UNITED STATES PATENT AND TRADEMARK OFFICE

APPLICATION NO.	FILING DATE	FIRST NAMED INVENTOR	ATTORNEY DOCKET NO.	CONFIRMATION NO.
10/613,256 -	07/03/2003	Gerhard Reichert	1663-A1	4893

Office Action Summary

FIG. 2

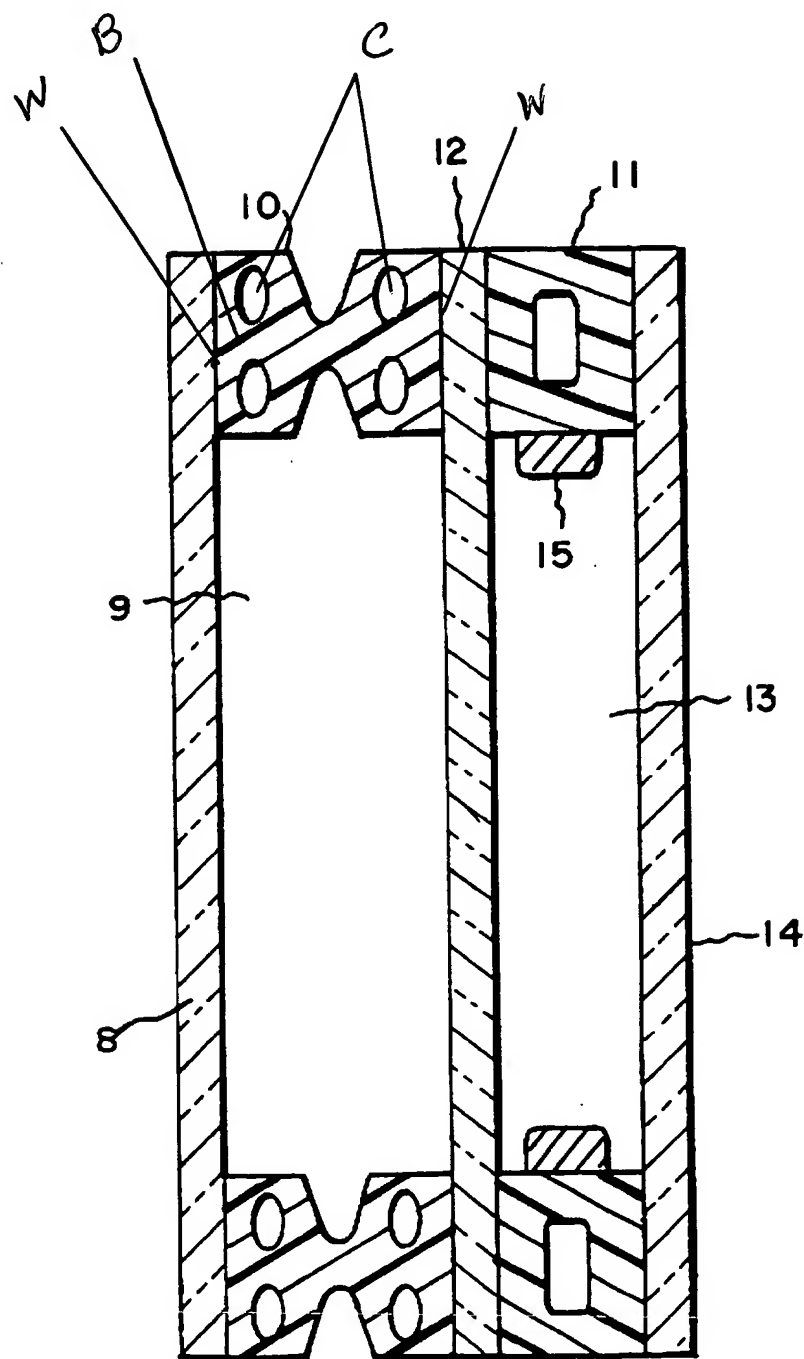
In regard to claims 1, 13 and 29: Milikovsky discloses the claimed invention Fig. 2, column 2, lines 5-19, a spacer 10 adapted to be disposed between opposed panes of glass 8 and 12 in a glazing unit; the spacer 10 including a body B (see attachment) which formed from body material having opposed base walls W (see attachment) separated by the height of the body B; each base wall W adapted to be disposed adjacent an interior surface of the glass panes 8 and 12; the body B defining at least one insulating cavity C (see attachment) which insulating cavity C having a cross sectional area and being surrounded by the body B, column 2, lines 54-57, silicon adhesive used to seal the two panes 8 and 12 hermetically and the body material having a cross section which is greater than the cross sectional area of the insulating cavity.

In regard to claims 2-3: Milikovsky discloses the claimed invention Fig. 2, the body B defines a longitudinal direction and insulating cavity C extending continuous in the longitudinal direction.

In regard to claim 4: Milikovsky discloses the claimed invention Fig. 2, the spacer 10 wherein the body B defines a plurality of insulating cavities C, each of the insulating cavities C extending continuously in the longitudinal direction.

In regard to claims 5-6: Milikovsky discloses the claimed invention Fig. 2, the insulating cavities C are spaced from one another and each insulating cavity has a width, the space between the insulating cavities C being equal to the width of the either insulating cavity C.

In regard to claims 30: Milikovsky discloses the claimed invention Fig. 2, column 2, lines 5-19, a spacer 10 adapted to be disposed between opposed panes of glass 8 and 12 in a glazing unit; the spacer 10 including a body B (see attachment) which formed from body material having opposed base walls W (see attachment) separated by the height of the body B; each base wall W adapted to be disposed adjacent an interior surface of the glass panes 8 and 12; the body B defining at least one insulating cavity C (see attachment) which insulating cavity C having a cross sectional area and being entirely surrounded by the body B, column 2, lines 54-57, silicon adhesive used to seal the two panes 8 and 12 hermetically and the body material having a cross section which is greater than the cross sectional area of the insulating cavity, the body B defining a longitudinal direction and insulating cavity C extending continuous in the longitudinal direction. Milikovsky does not disclose the body formed from resilient foam. Glover teaches Fig. 1, column 6, lines 59-62, the body of spacer 40 is formed from foam material. It would have been obvious to one of ordinary skill in the art at the time of invention was made to formed the body from foam material in order to have body with durability, good resilience, high temperature stability and cold temperature flexibility.
